Access Compliance Report

Public Rights-of-Way

Intersection ID: 16073	Main Street: AUBURN_AV	Cross Street: MELBOURNE_CT	Location:	N
ADA ID: A92C7A011324	Ramp Type: BlendTrans2	Initial Pass/Fail: Fail	Overall Compliance: No	Severity Score: 10

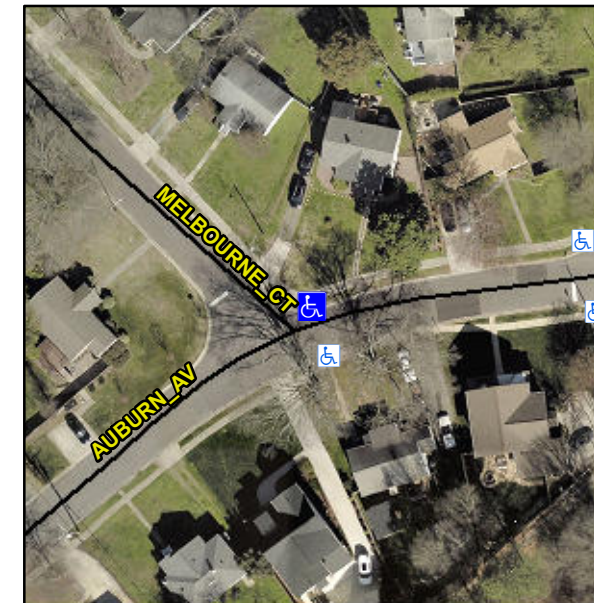
NO LNDG

Not Found, R304.5.1, R304.5.3

Compliance	Description	Data	Compliance	Description	Data
N/A	Ramp Length (in)	107.0	Yes	BlendTrans Slope (%)	3.7
No	Ramp Width (in)	46.0	No	BlendTrans XSlope (%)	3.3
N/A	Flare Type LT	N/A	N/A	Flare Type RT	N/A
N/A	Flare Slope LT (%)	N/A	N/A	Flare Slope RT (%)	N/A
N/A	Flare Traversable LT?	N/A	N/A	Flare Traversable RT?	N/A
N/A	Landing Length (in)	N/A	N/A	DWS Provided?	N/A
N/A	Landing Width (in)	N/A	N/A	DWS Contrast?	N/A
N/A	Landing Slope (%)	N/A	N/A	DWS Length (in)	N/A
N/A	Landing X Slope (%)	N/A	N/A	DWS Full Width?	N/A
N/A	Landing Curb? (Y/N)	N/A	N/A	DWS Offset (in)	N/A
N/A	Shared Landing?	N/A			
N/A	Gutter Ponding?	N/A	N/A	Gutter Slope (%)	N/A
N/A	Gutter Lip Ht (in)	N/A	N/A	Gutter X Slope (%)	N/A
N/A	Painted X Walk1?	No	N/A	Painted X Walk2?	N/A
	X Walk 1 Direction	To S		X Walk 2 Direction	N/A
	X Walk 1 Width (in)	N/A		X Walk 2 Width (in)	N/A
	X Walk 1 Slope (%)	0.8		X Walk 2 Slope (%)	N/A
	X Walk 1 X Slope (%)	2.5		X Walk 2 X Slope (%)	N/A

N/A	Ramp inside XWalk1?	N/A	N/A	Ramp inside XWalk2?	N/A
	Road Slope (%)	2.5		Clear Space?	N/A
	Road X Slope (%)	0.8	N/A	Clear Space to XWalk (in)	N/A
N/A	Any Obstructions?	N/A	N/A	Storm Grate/Utility Hazard?	N/A
	Obstruction Type			Storm Grate/Utility Type	
		N/A			N/A
			Yes	Surface Condition? (G/P)	Good
			No	Curb Slope (%)	17.3

Remove & Replace Curb Ramp With Two New Directional Ramps or Equivalent.
